RE: Letter of appeal to City of Victoria Mayor and Council regarding a garden suite application

### Response to concern regarding impact on neighbors' privacy

**224 ROBERTSON GARDEN SUITE**

Figure 1 - Landscape plan: The locations and directions from where I took photographs shown in Pictures 1-2

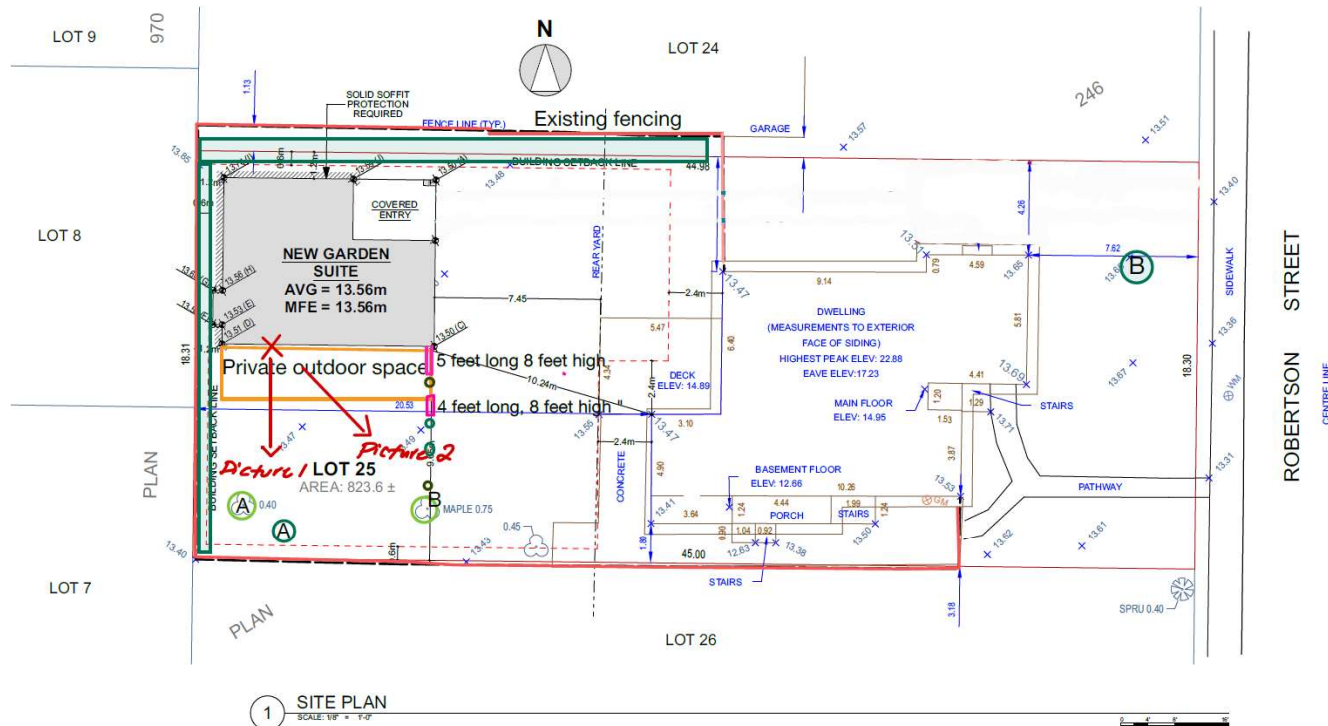
This document responds to the concern raised during the DDP review regarding the impact that windows will have on the neighbors, and proposes revisions to address these issues. Specifically, three issues regarding neighbors' privacy were raised in the Application Review Summary:

- *Please provide more details of landscaping and screening on landscape plan to show how privacy impacts will be mitigated from principal dwelling and view into adjacent lot (south).*
- *The Garden Suite Design Guidelines discourage windows facing neighboring properties. Reduce the amount and size of windows on the south elevation.*
- *Window on north and west elevations should be small and opaque to reduce potential privacy issues. Ensure windows into kitchen area on north elevation are transom windows with appropriate height to discourage overlook. Please consider size of windows framing fireplace. Please label glazing as opaque on these elevations.*

The revised design (refer to attachment 8 - Drawings) includes the following changes to the window design that have been implemented to mitigate privacy impacts:

- The size of the south facing (living room) window has been reduced by 28 square feet.
- The overall number of windows on the south elevation has been reduced.
- In addition to the existing landscaping and previously proposed landscaping, further landscaping has been added in strategic locations that obscure sightlines. The proposed wood privacy screens and dense ever green shrubs will be installed or will grow to the appropriate height such that they block visibility.
- The window on the east elevation that (due to the relative positioning of the garden suite and south neighbor's principal dwelling) had the clearest sightline to the neighbor's house has been reconfigured.
- The windows on the north and west elevations will be translucent and non-opening.
- The windows in the kitchen area have been raised to an appropriate height.

- The window on the east elevation that (due to the relative positioning of the garden suite and south neighbor's principal dwelling) had the clearest sightline to the neighbor's house and thus posed the largest imposition on privacy has been removed.
- The size of the south facing (living room) window has been reduced by 28 square feet.
- The overall number of windows on the south elevation has been reduced.
